January 20, 2021

ATTENTION ALL REQUEST FOR BID (RFB) HOLDERS

**RFB NO. 319032 - ADDENDUM NO. 1
HIGHWAY SATTELITE BUILDING-ALBION**

1015 COUNTY HIGHWAY A - 50'x100' BUILDING
GRADING AND EROSION CONTROL PLAN
EXHIBIT #3 Asphalt Boundary
DATED: AUGUST 13, 2020

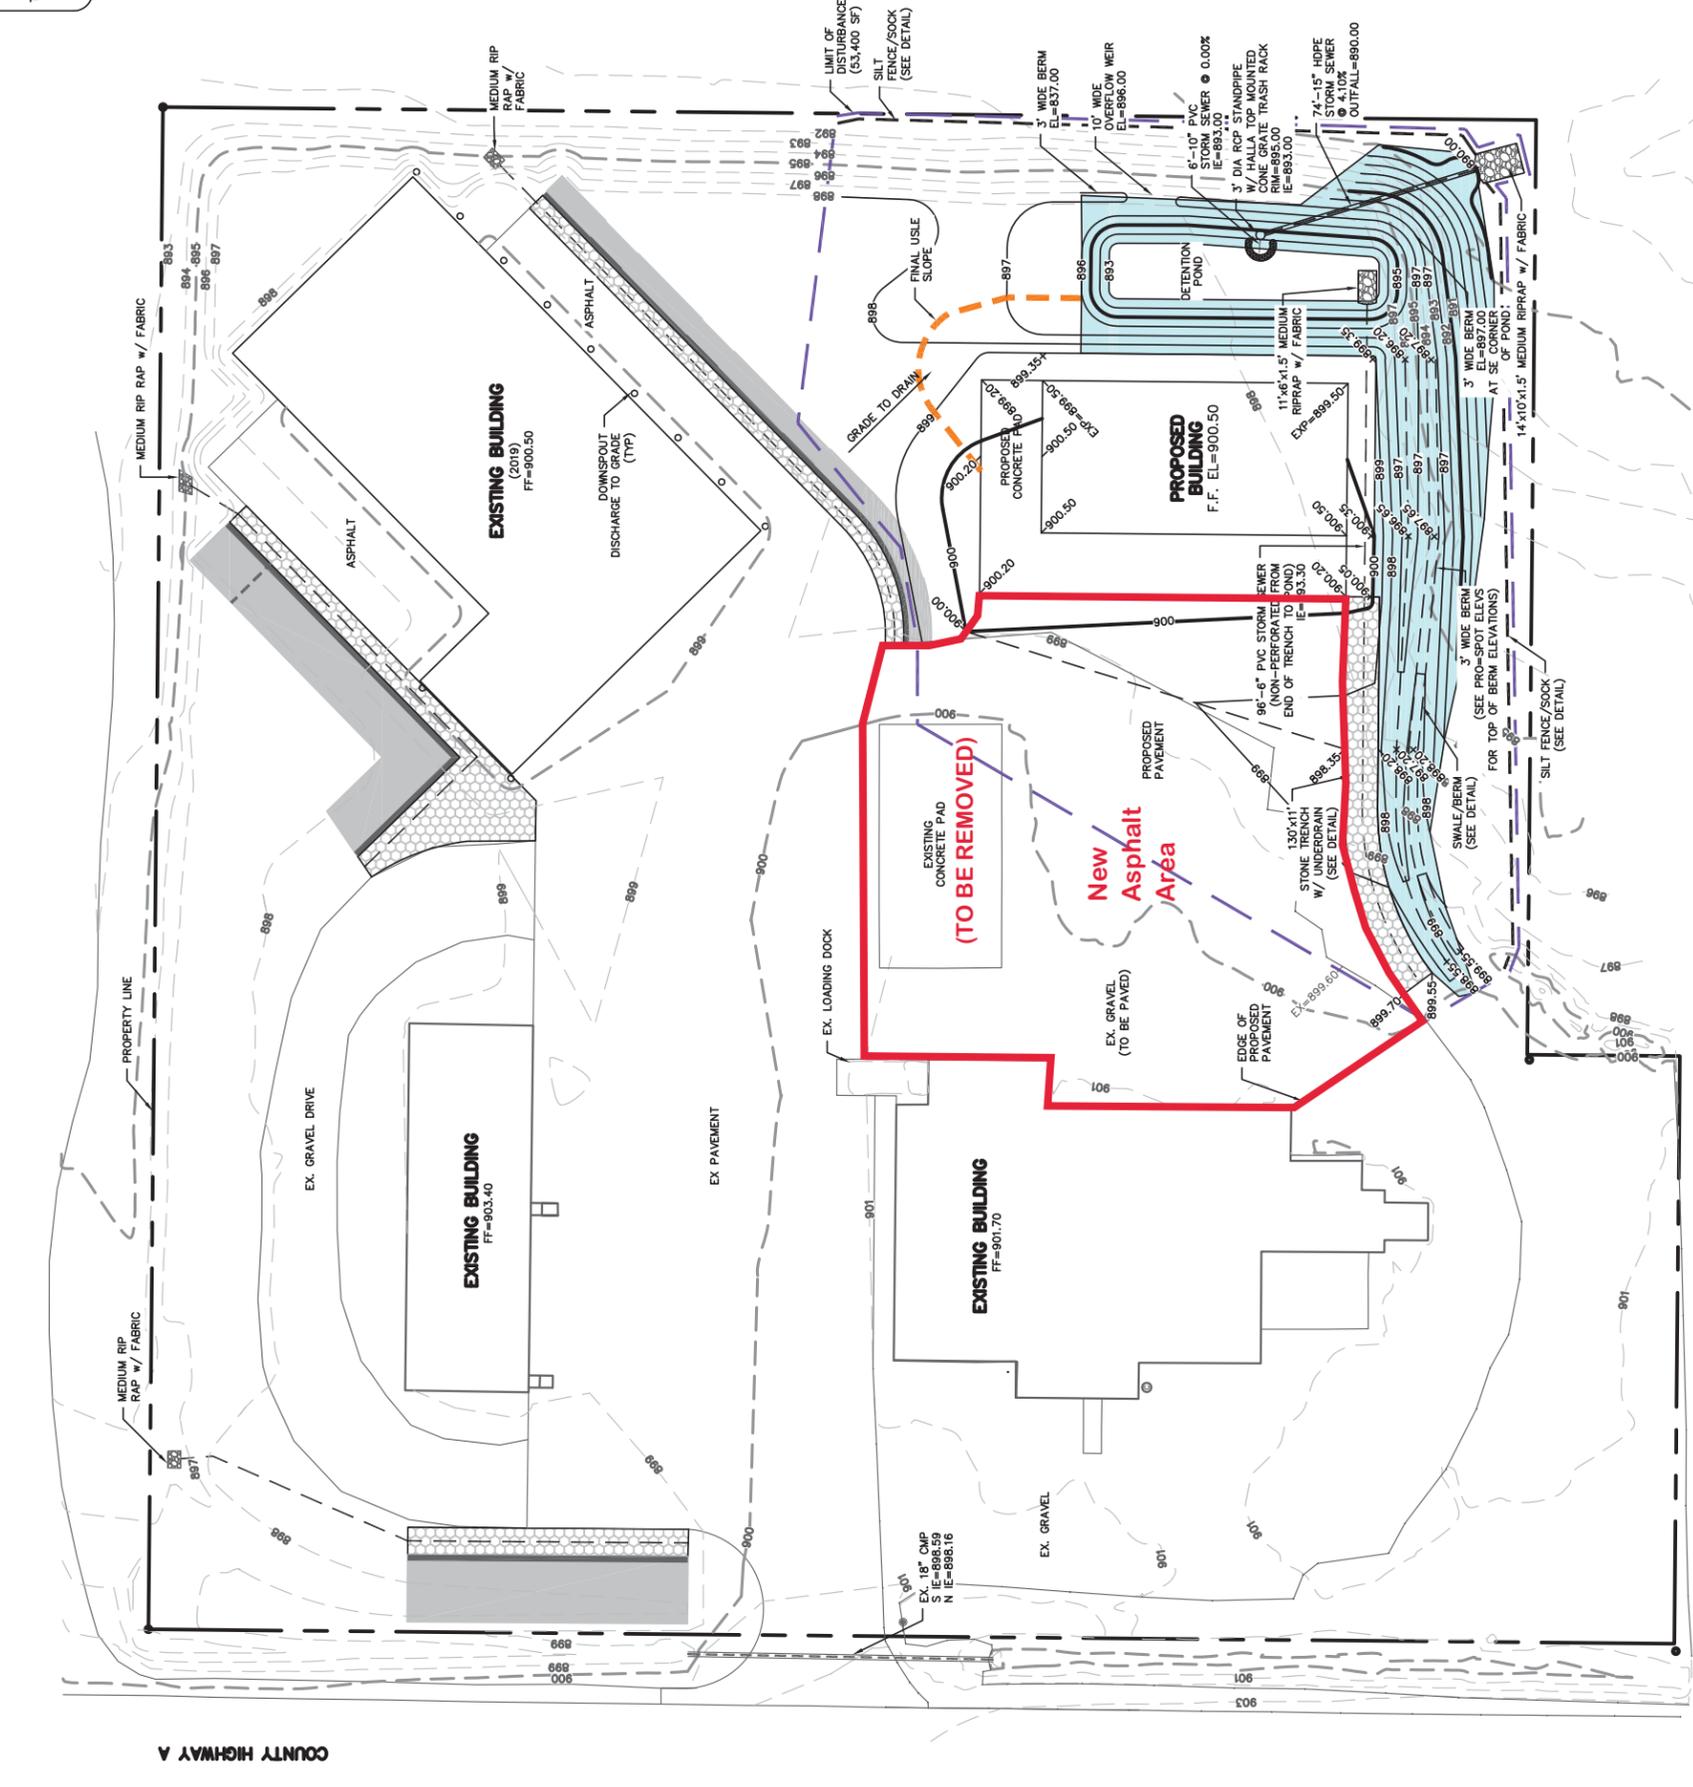
- 1. Section 32 12 16 Asphalt Paving**
Add Section 32 12 16; issued with this Addendum to Bid Documents
- 2. Section 08 71 00**
Page 4 - Delete reference for automatic swing door operator.
- 3. Sheet Exhibit #3 – Asphalt Boundary**
Add Sheet Exhibit #3 Asphalt Boundary, issued with this Addendum.

37. Q, Confirm asphalt paving is required per Quam Engineering site plan dated 8/13/20. There is no information is specs.

38. Q, I was told that there is asphalt on this project. I wanted to clarify on the area that you are looking for. I attached a highlighted plan that would be around 22,500 SQFT of new asphalt. Let me know if this is the area that you are looking to have the new asphalt.

A: See the asphalt specification and clarification drawing included with this addendum for the Albion site. Asphalt paving is not anticipated for the Verona site.

A: See the asphalt specification and clarification drawing included with this addendum for the Albion site. Asphalt paving is not anticipated for the Verona site.
